ENVIRONMENTAL PROTECTION AGENCY**40 CFR Parts 63, 264 and 266**

[EPA-HQ-OAR-2004-0022; FRL-8215-3]

NESHAP: National Emission Standards for Hazardous Air Pollutants: Standards for Hazardous Waste Combustors (Reconsideration)**AGENCY:** Environmental Protection Agency (EPA).**ACTION:** Proposed rule.

Figure 1. Time Line for Phase 1 Replacement Standards and Phase 2 Standards – Existing Sources

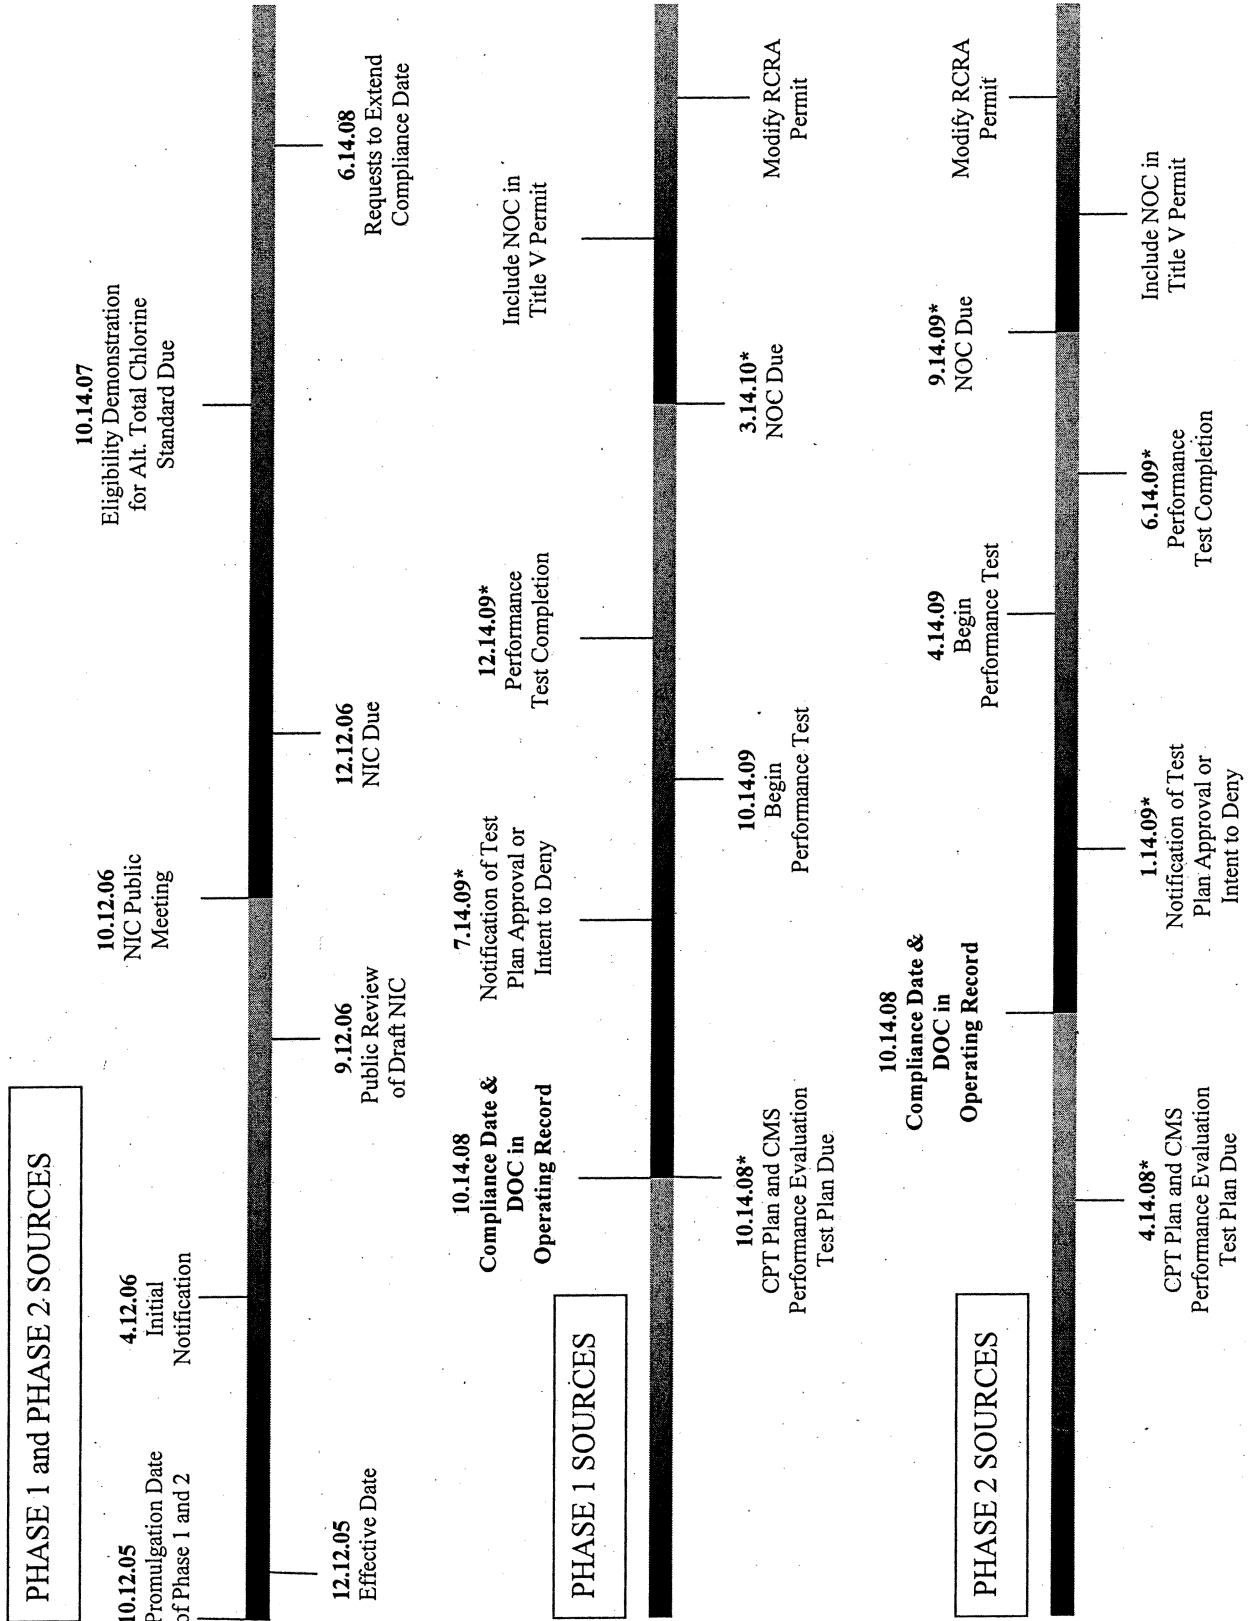
The time line labeled as Figure 1 published in the final rule at 70 FR at 59524, depicts an incorrect "effective" date for the Phase 1 Replacement Standards and Phase 2 Standards final rule. As a result, all subsequent dates on the time line are also incorrect. The time line labeled as Figure 2 published in the final rule at 70 FR at 59525 incorrectly includes the rule's effective date, as well as subsequent dates based on the effective date. Today's notice revises both time lines to reflect the correct dates or time frames associated with the compliance activities for both Phase 1 and Phase 2 sources. In addition to revising the dates, we felt it would be helpful to include the following remarks for both Figures 1 and 2.

With respect to figure 1, the time line is now broken into three sections to reflect the separate requirements (*i.e.*, different time frames) negotiated for Phase 1 sources for the Replacement Standards. The first section of the time line, beginning with the promulgation date, provides compliance activities and dates applicable to both Phase 1 and Phase 2 sources. The second and third portions of the time line represent Phase 1 and Phase 2 sources individually, beginning with the first compliance activity that specifies a different deadline; that is, the comprehensive performance test (CPT) plan and continuous monitoring system (CMS) performance evaluation test plan due date.

Note that the dates on the time line generally do not apply to sources that elect to comply with the final standards early, as well as to sources that have received site-specific compliance date or performance test date extensions. Also, as a result of expanding the time line into three sections from the previous two, we have removed the note at the bottom of the page, identified by an asterisk that discussed Title V requirements, to provide better visual clarity. Rather, we have chosen to

Finally, the compliance activity dates that are tied to when sources commence their performance test are identified with an asterisk. We characterize these dates as "no later than dates." This assumes that the source commences testing on the last allowable day. All compliance activities marked with an asterisk would therefore shift back by the number of days the source commences testing prior to the last allowable day. For example, if a Phase 2 source commences testing on April 4, 2009 (versus the 14th, which is the last allowable day without an extension), then it must submit its CPT plan and CMS performance evaluation test plan on April 4, 2008. Also, that source must complete its CPT by June 4, 2009 and submit its notification of compliance no later than September 4, 2009.

Figure 2. NIC and CPT Plan Time Line - New Units

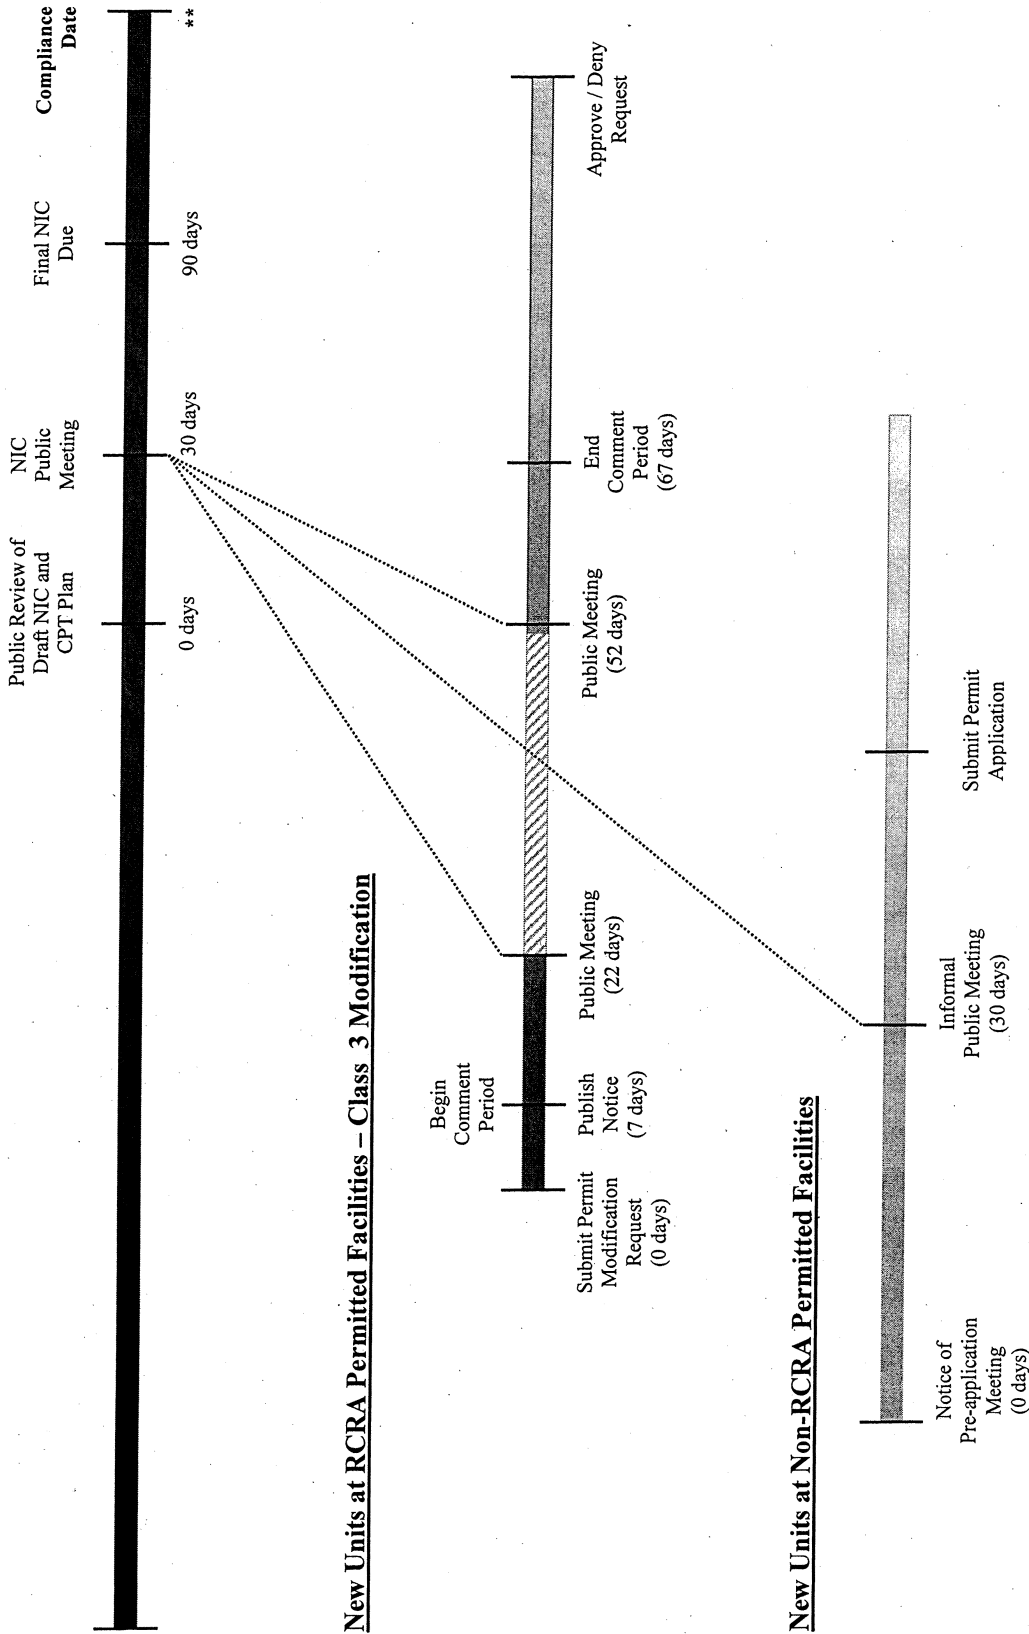
In regard to Figure 2, we have removed the dates from the time line, since they would not be representative of a new unit's compliance deadlines. A new unit's compliance activity deadlines are based on when it begins operations, which is the unit's compliance date and the date it must place a Documentation of Compliance in the operating record. Thus, the effective date of the rule is not applicable to new units and consequently, the Notice of Intent to Comply (NIC) provisions in §§ 63.1210(b)(3) and (c)(1) that specify a deadline based on the effective date of the rule, also would not apply. Since we have always intended that new units follow the same NIC procedures as existing units, we have revised §§ 63.1210(b)(3) and (c)(1) to also include the period of time between the NIC activities so that they correctly apply to both existing and new units. (See Section VII.C (Clarifications to the NIC Provisions for New Units) below for additional discussion.) The time line now reflects the period of time that elapses between public review of the draft NIC and CPT plan, the NIC public meeting, and the final NIC submission deadline. Aside from the corrections

While revising the time line for new units (see Figure 2 shown above in Section VI (Revised Time Lines)) it became apparent that we overlooked the fact that the final rule's effective date has no bearing on new units. A new unit's compliance activity deadlines are based on when it begins operations, which is the unit's compliance date and the date it must place a Documentation of Compliance in the operating record. Therefore, the NIC deadlines are only based upon each individual NIC compliance activity. For example, the clock will begin when the new unit provides the draft NIC and draft CPT plan to the public for review. Once the draft NIC and draft CPT plan are made available for public review, the combined public meeting must occur 30 days later, followed by the final NIC submission an additional 60 days later. Since the public meetings for the NIC and the RCRA pre-application or modification request must occur simultaneously, we anticipate that the new unit will plan accordingly and work with its permitting authorities to determine the most suitable time to begin the NIC compliance process.
